LOST CREEK ISR, LLC

**Re: Annual Report of Changes, Tests, or Experiments Pursuant to License Condition 9.4(E)
Lost Creek ISR Project
License SUA-1598 Docket 40-9068**

Attachment 1: SERP Summary
2016 Annual Report of Changes, Tests, or Experiments
Lost Creek ISR Project SUA-1598

LEGEND	
	Point Source Ventilation with Fan
	Point Source Ventilation
	Duct Fan

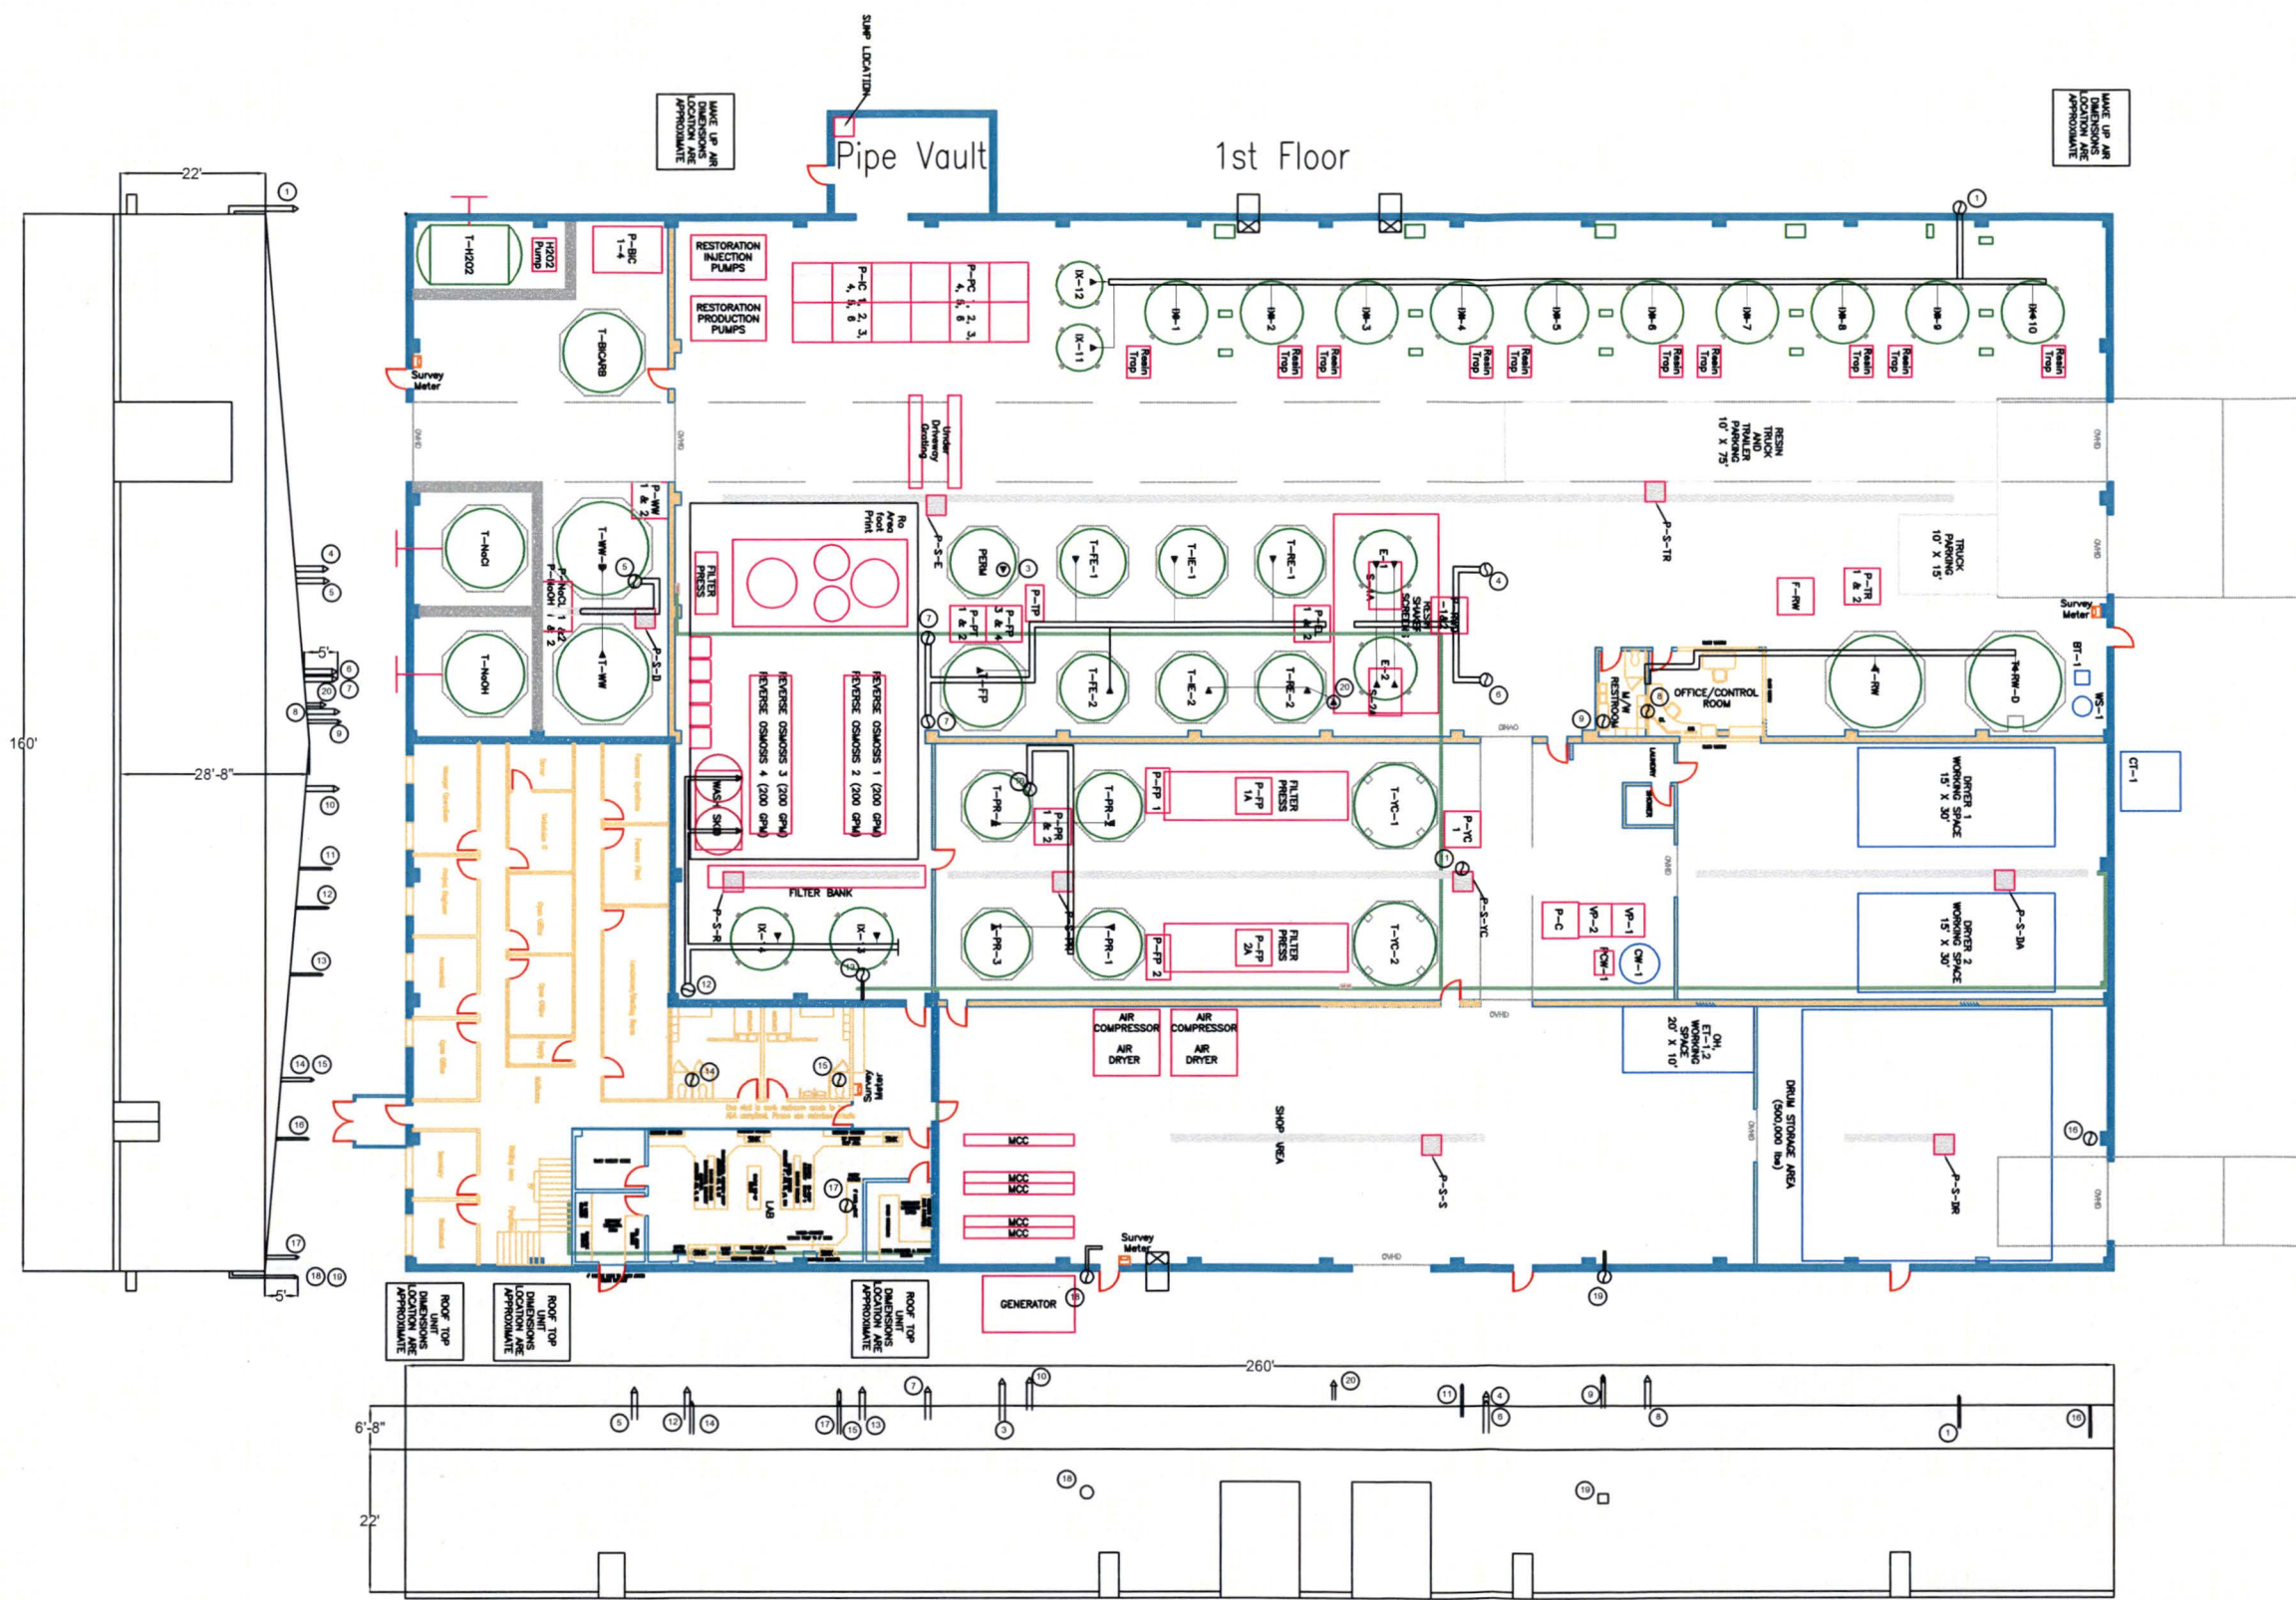
4	Dec 2016	Technical Report Section 4	Figure 4.1-3 (Jun16)	Figure 4.1-3 (Jan17)	Added vent modification for IE2 and RE2 tanks	SERP LC16-11

Figure 5.1-1 Lost Creek ISR, LLC Organization Chart

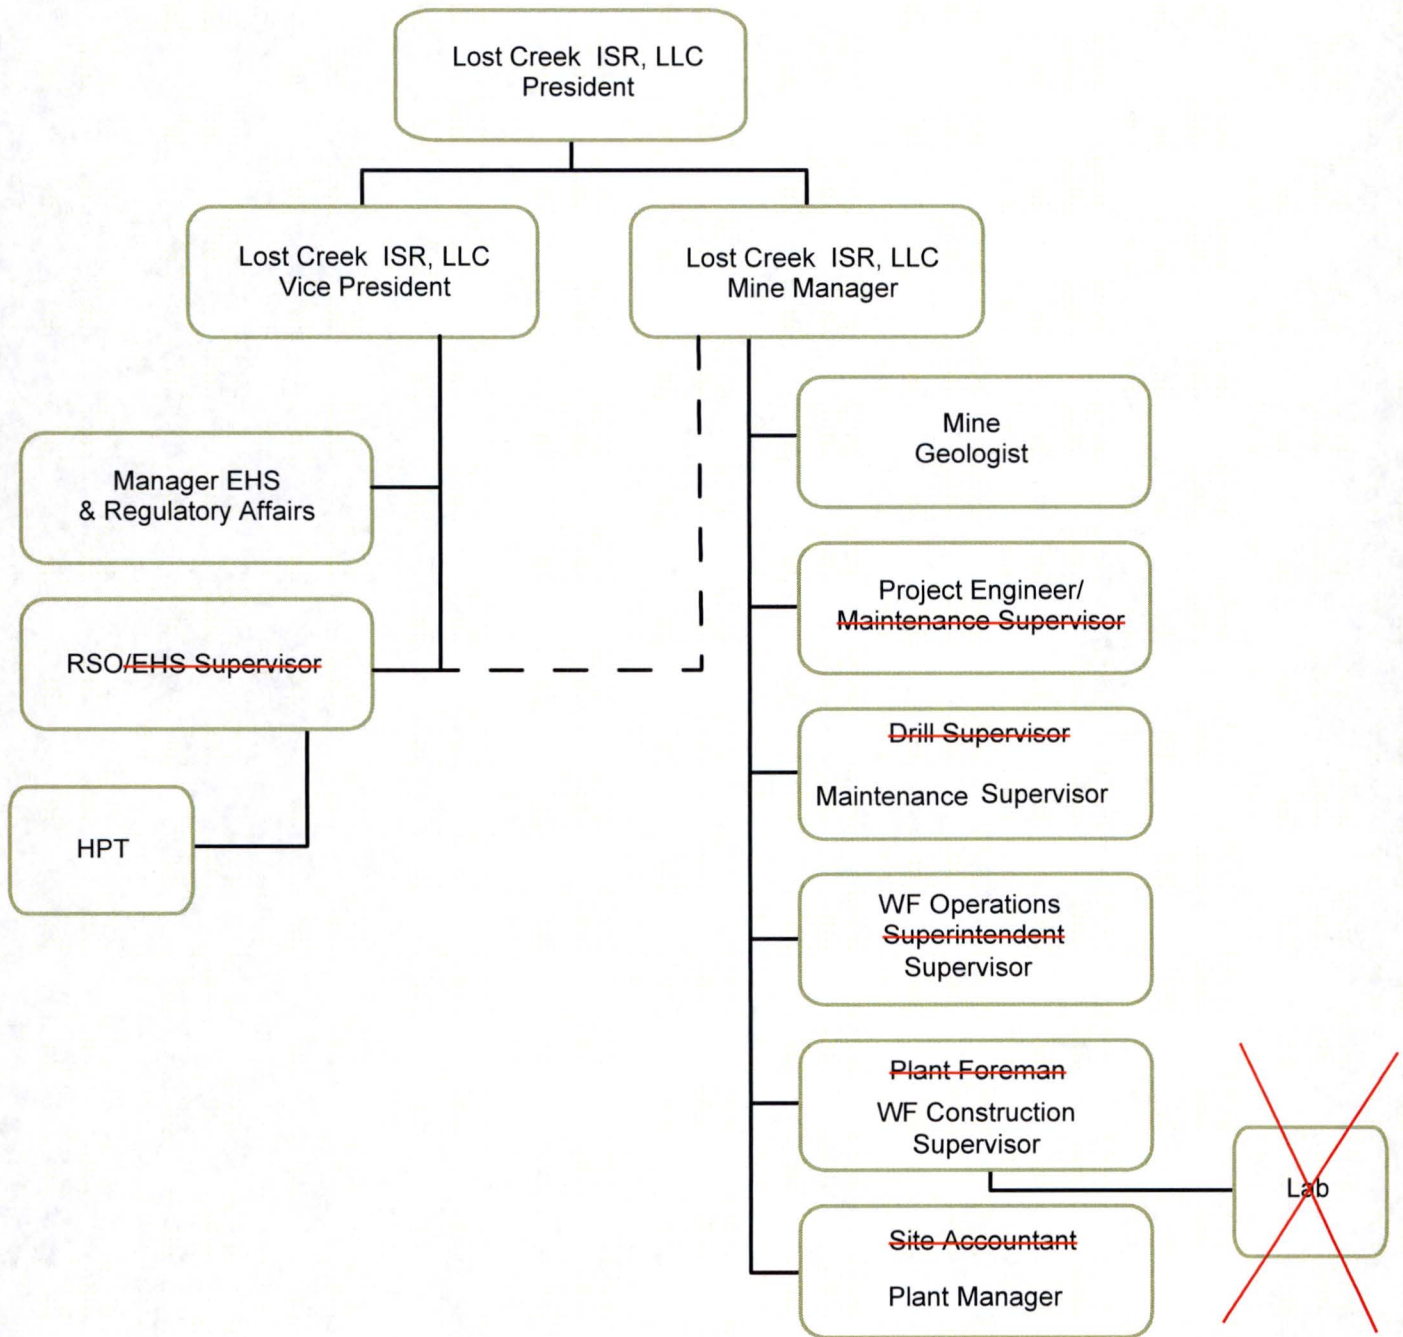
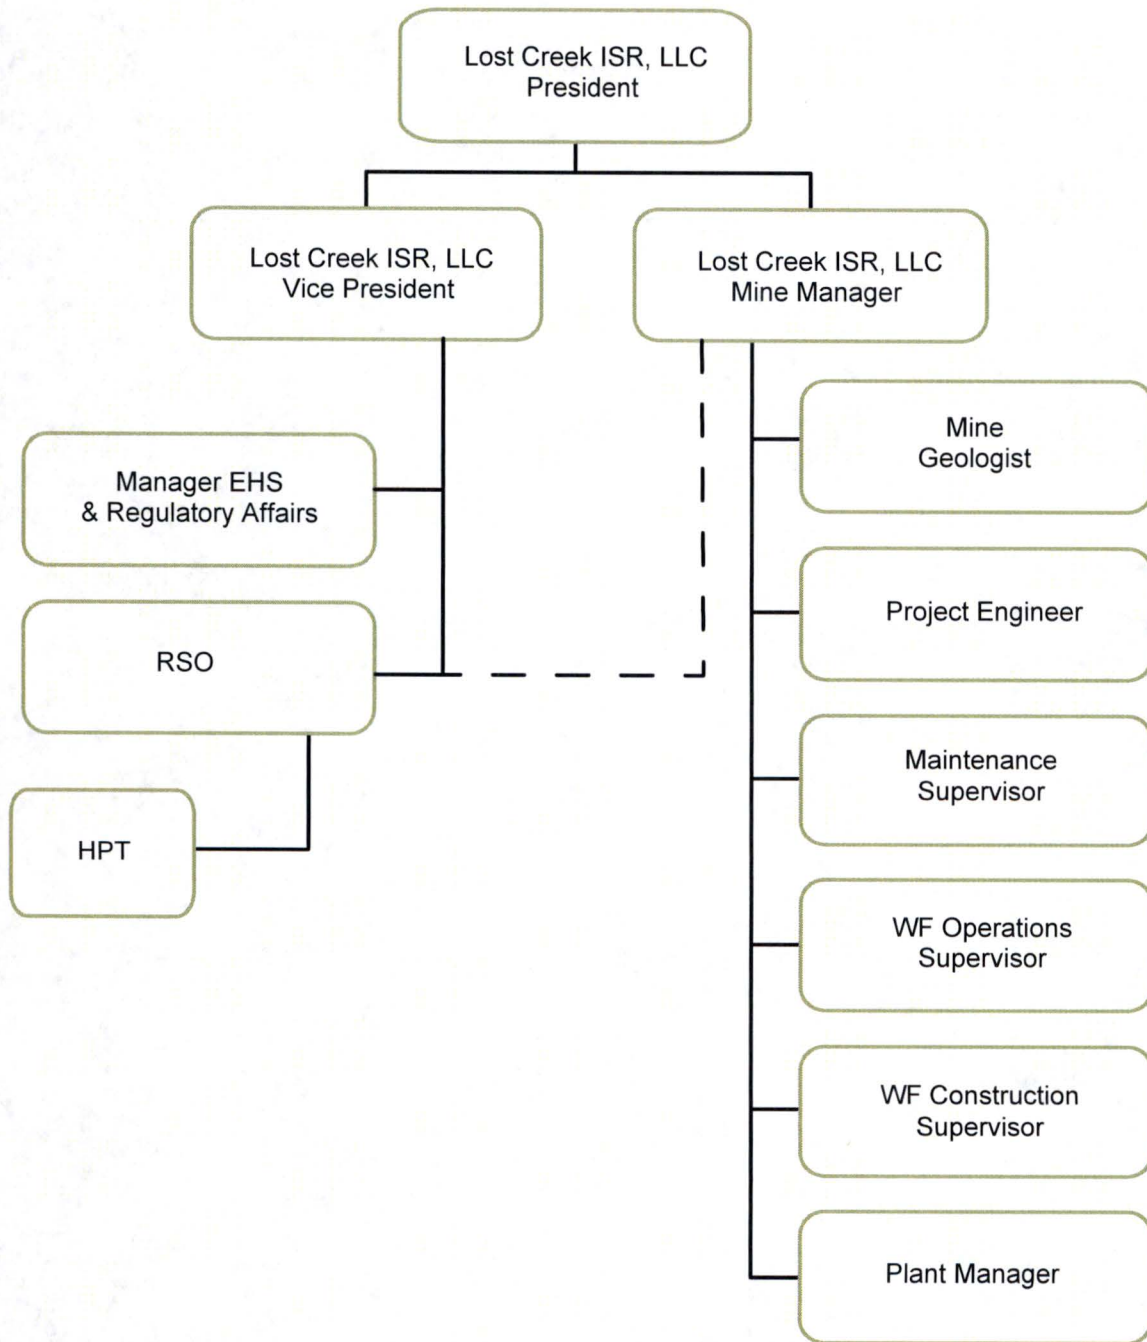
The changes to the Org Chart were reviewed and compared to the language in the TR and Chart in the TR. The TR language and Org Chart were made to coincide with the LC Org Chart and footnotes were to be added to the LC Org Chart if job titles were not listed exactly as described in the TR. The main changes were:

- Drill Supervisor was removed from Department Heads and placed under the Mine Geologist
- Wellfield Operations Superintendent was split into the Department Heads of Wellfield Operations Supervisor and Wellfield Construction Supervisor.
- The Site Accountant was removed from the Department Heads
- EHS Supervisor was removed from the RSO title (the RSO responsibilities do not change as a result).
- The Department Head of Plant Foreman was changed to Plant Manager
- References to General Manager or Operations Manager were removed since those positions are not part of the LC organizational structure. The Vice Presidents, Manager

Revise Technical Report Section 5.1 and associated Figure 5.1-1 to be consistent with current Lost Creek Project organizational structure.

The changes to the TR Section 5 and Figure 5.1-1 were approved by the SERP. Footnotes will be added to the LC Org Chart to reference the positions as described in the TR if the job titles differ slightly.
